Item Name: AS350/AS355 Quick Release Heli-Utility-Basket™ Long, Heavy Duty Lid

DART SERVICE INSTRUCTION

TO AMEND INSTALLATION INSTRUCTIONS D350-607-3 Rev.D,

INSTALLATION INSTRUCTIONS D350-607-4 Rev. C AND INSTRUCTIONS FOR CONTINUED AIRWORTHINESS ICA-D350-607 REV. 6

FIGURE 1: INSTALLATION OF D4775-041 FWD STRUT

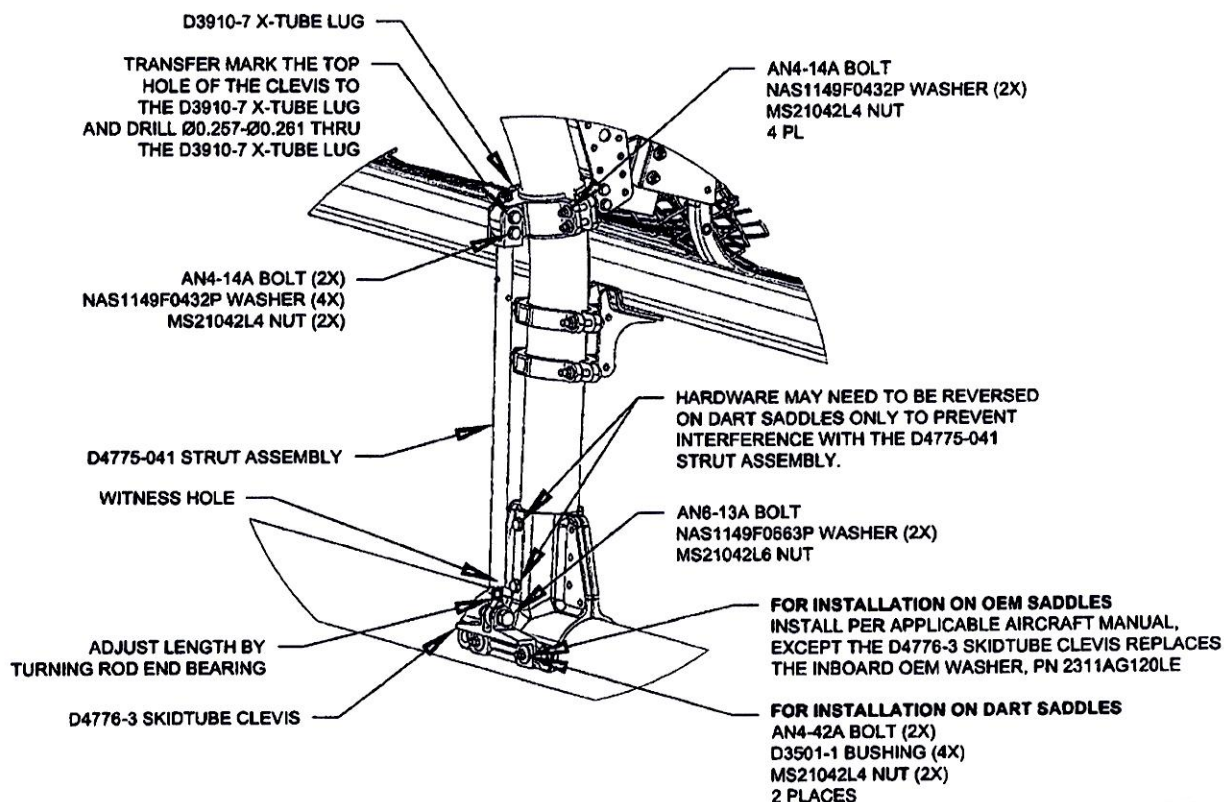
3.1 Substitute the Forward Lower D3910-5 X-Tube Lug with the D3910-7 X-Tube Lug as shown in Figure 1.

3.2 Install the forward D4775-041 Strut Assembly. Transfer mark from the upper hole on the clevis of the D4775-041 Strut Assembly to the D3910-7 X-tube Lug and drill thru the lug $\varnothing 0.257$ - $\varnothing 0.261$ as shown in Figure 1. Touch up chemical conversion coating per MIL-DTL-5541. Check the witness holes located at the bottom end of the D4775-041 Strut Assemblies to ensure that the thread from the rod end extends past the witness hole.
Torque MS21042L4/-4 nuts to 50-70 in-lbs (5.7-7.9 N-m). Torque MS21042L6/-6 nuts to 160-190 in-lbs (18.1-21.5 N-m).
